RESPONSES TO  
NRC QUESTION  
ON THE  
DUANE ARNOLD ENERGY CENTER  
PUAR

PREPARED BY  
NUTECH ENGINEERS, INC.  
SAN JOSE, CALIFORNIA

PREPARED FOR  
IOWA ELECTRIC LIGHT AND POWER CO.

NRC QUESTION ON DUANE ARNOLD ENERGY CENTER

Figure 5 - 2"  $\phi$

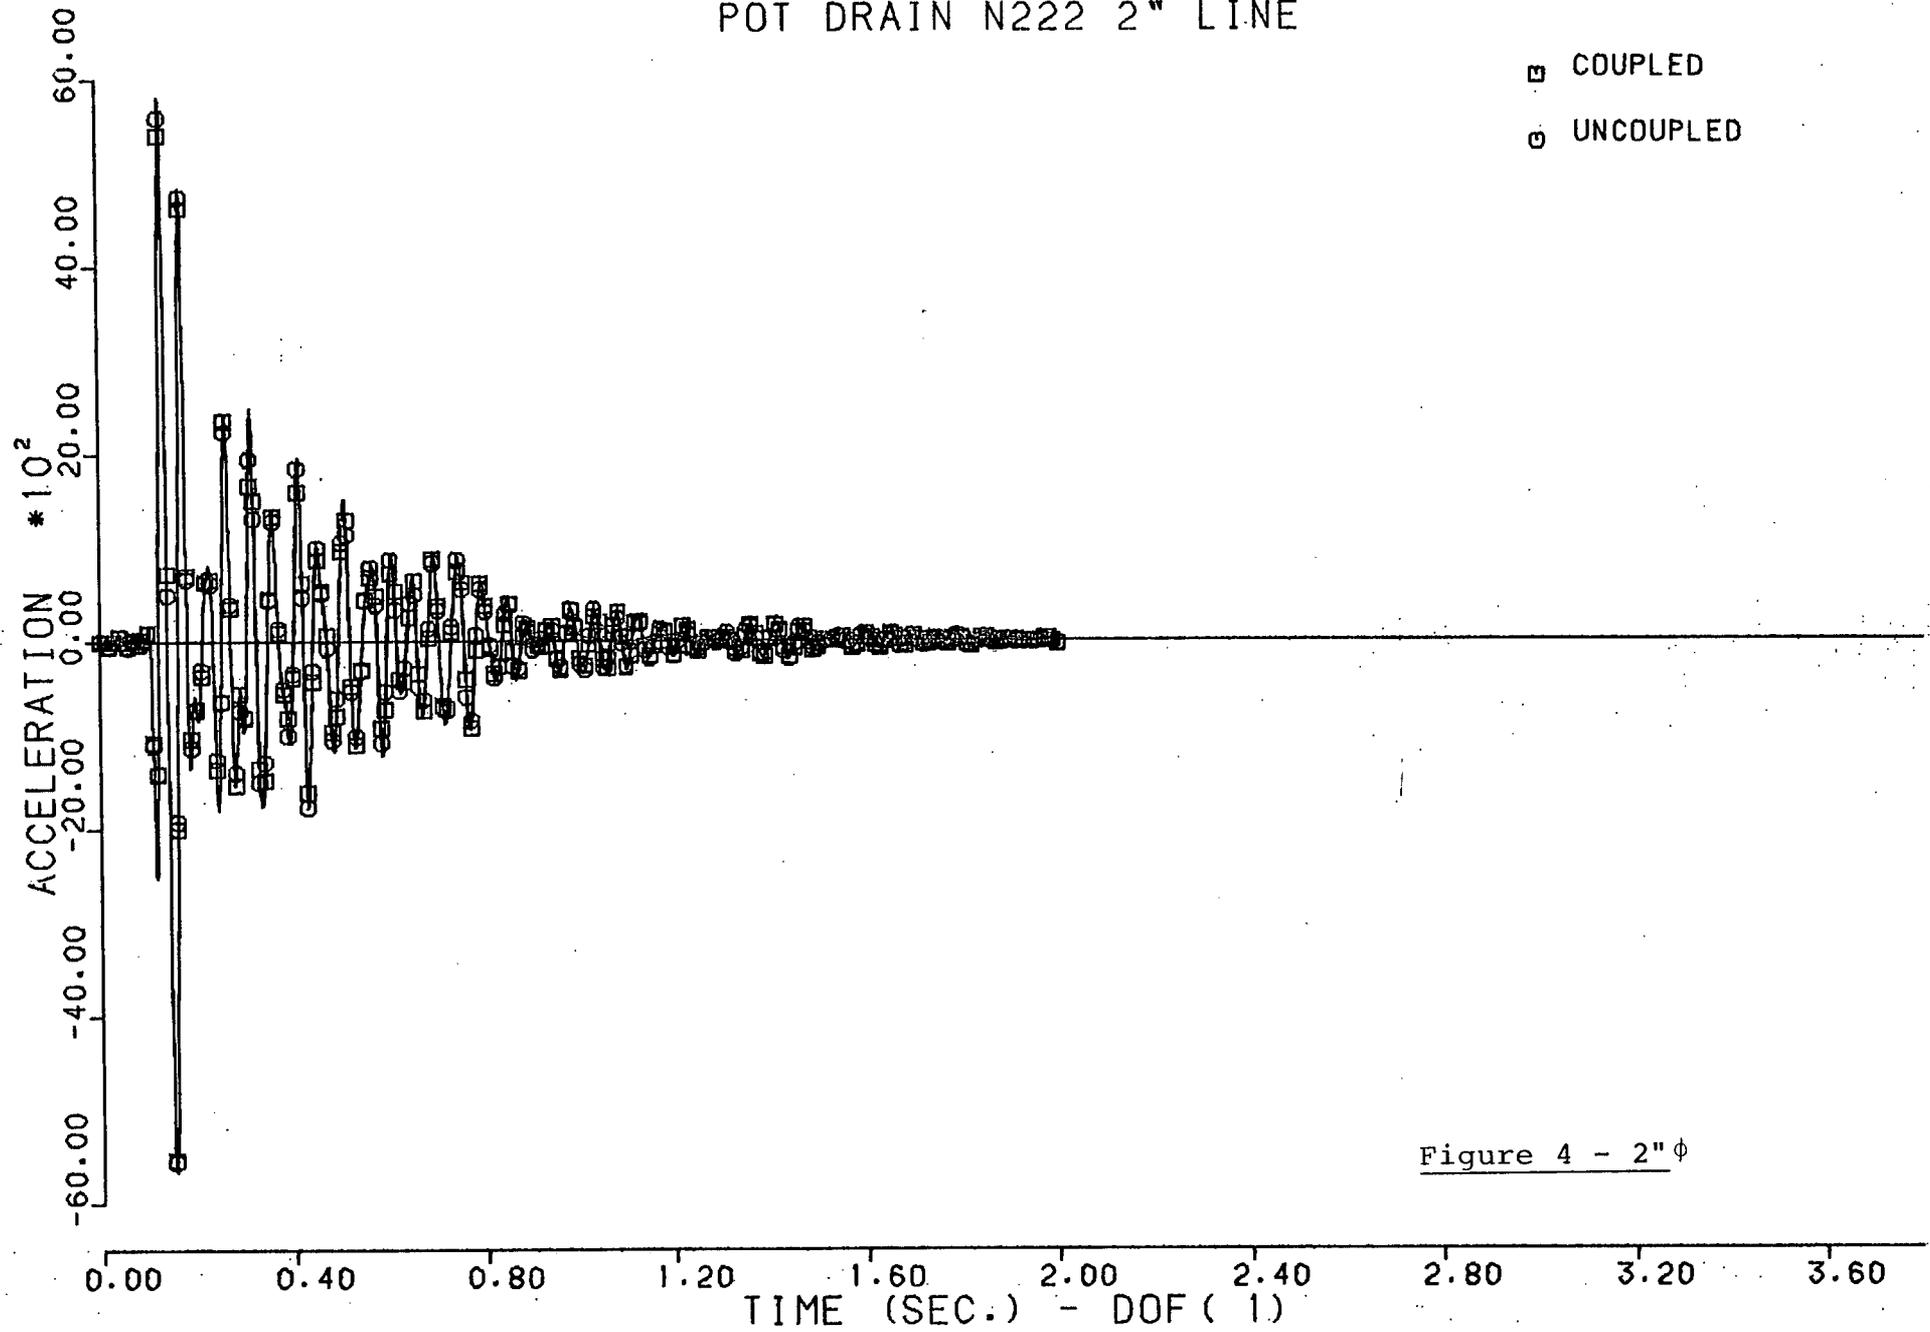
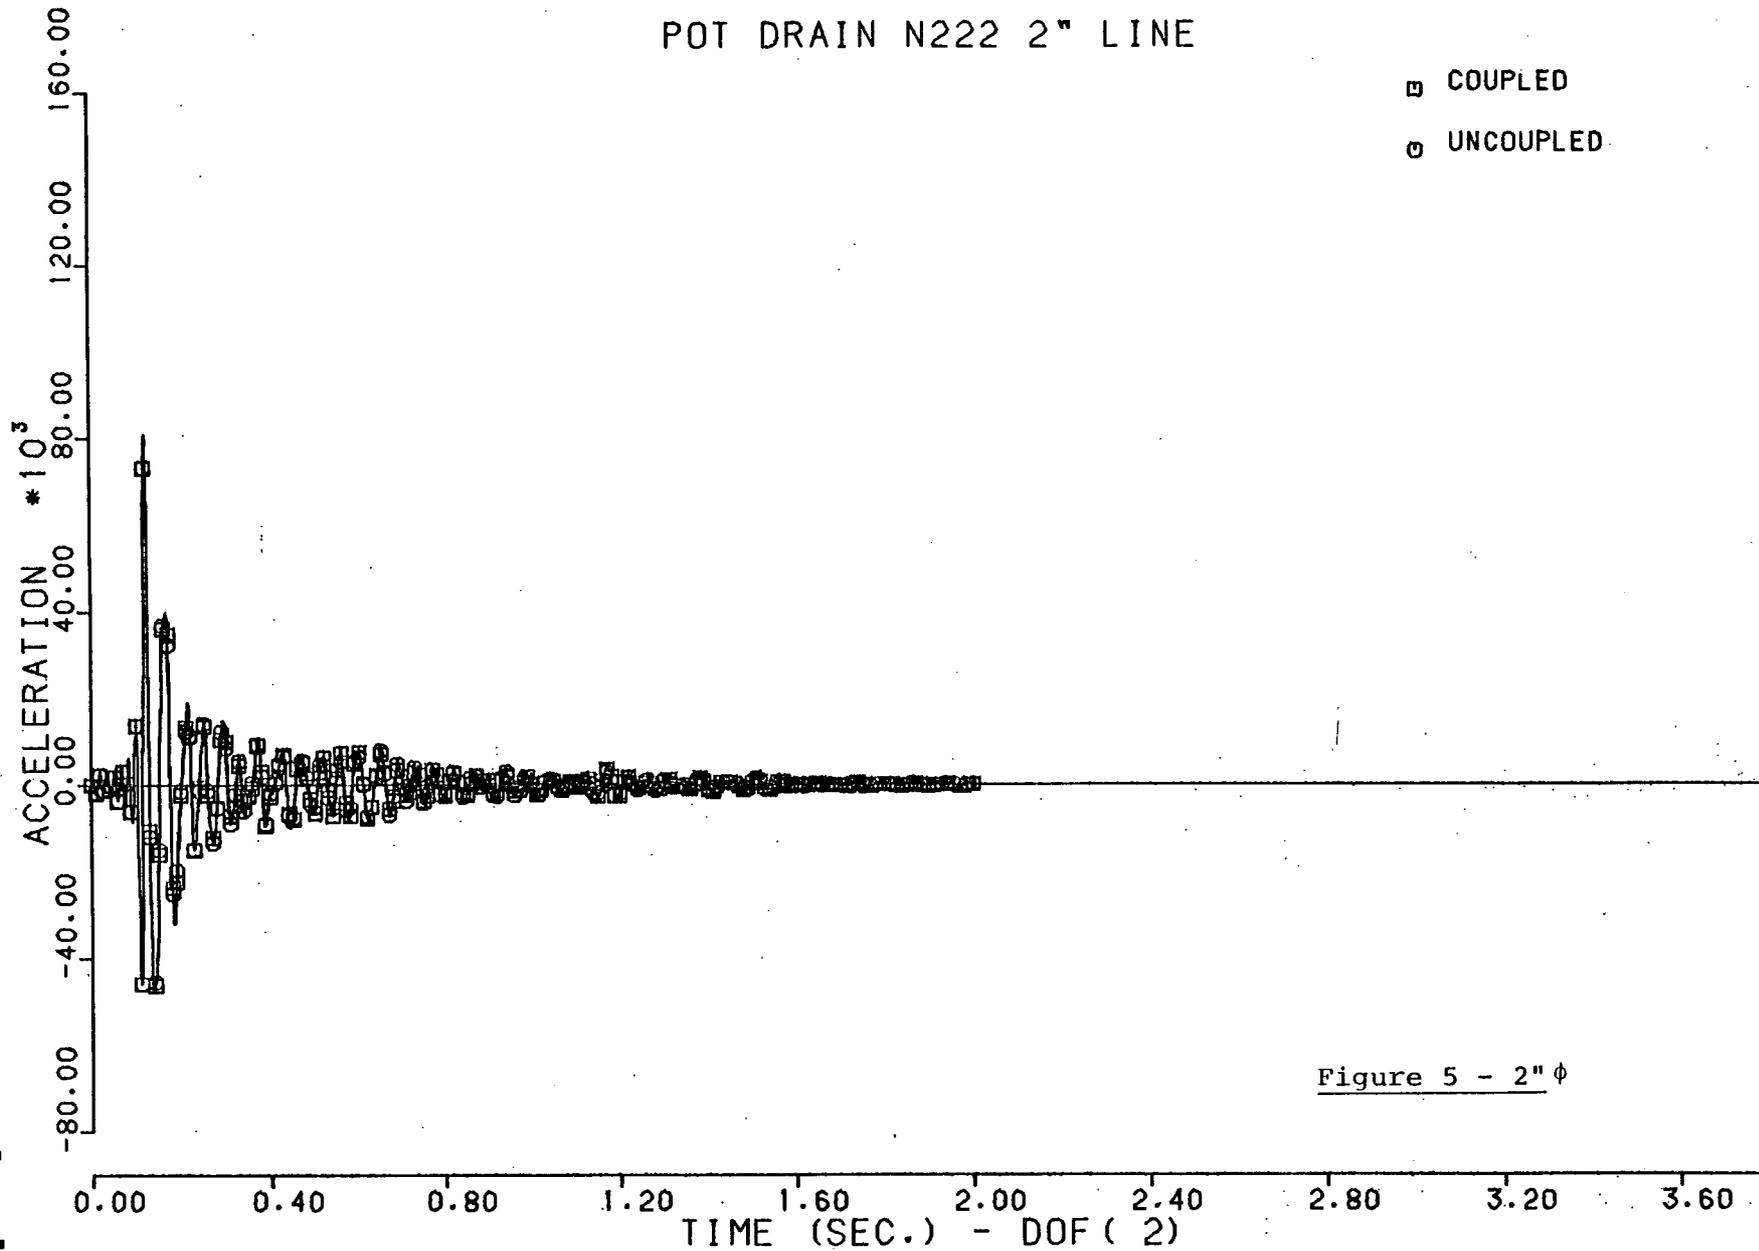
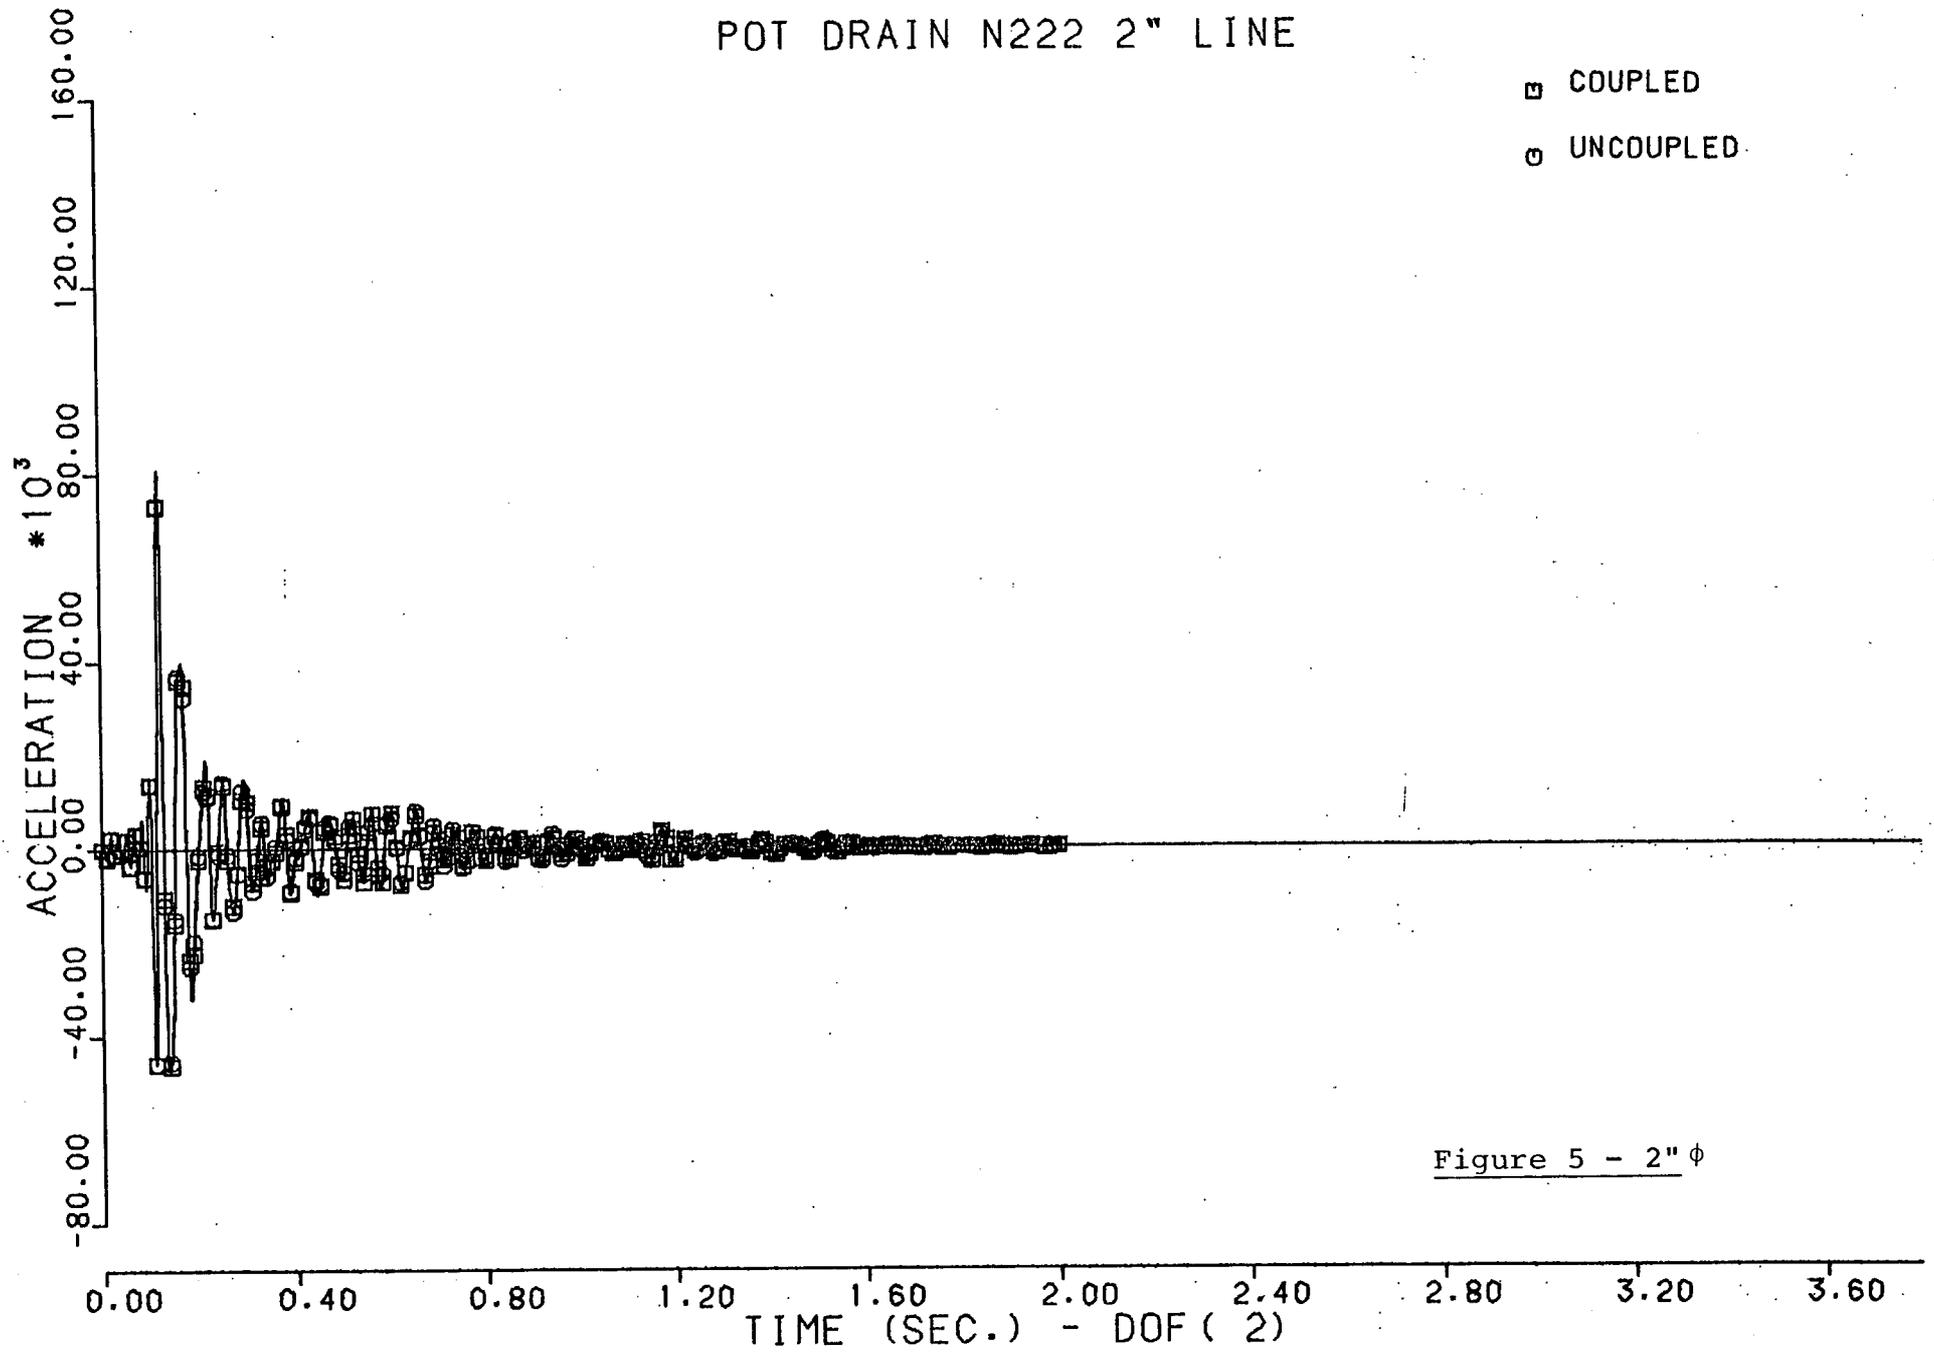
ITEM 3a: Provide the theoretical background in support of Section 2 of the report, and describe how the Section 6 guidelines (i.e., cut-off frequency and equations 2.27 and 2.28) have been used in the analysis.

To illustrate the effect of pipe size on coupling, four typical piping systems were examined and the coupled and uncoupled time histories plotted together. These time histories include both the smallest (2") and larger (20") systems analyzed. Listed below are the figure numbers and the corresponding line size.

Figure 4-8	2" diameter
9-13	4" diameter
14-18	6" diameter
19-21	20" diameter

These plots confirm the expected variation of coupling benefit with pipe size.
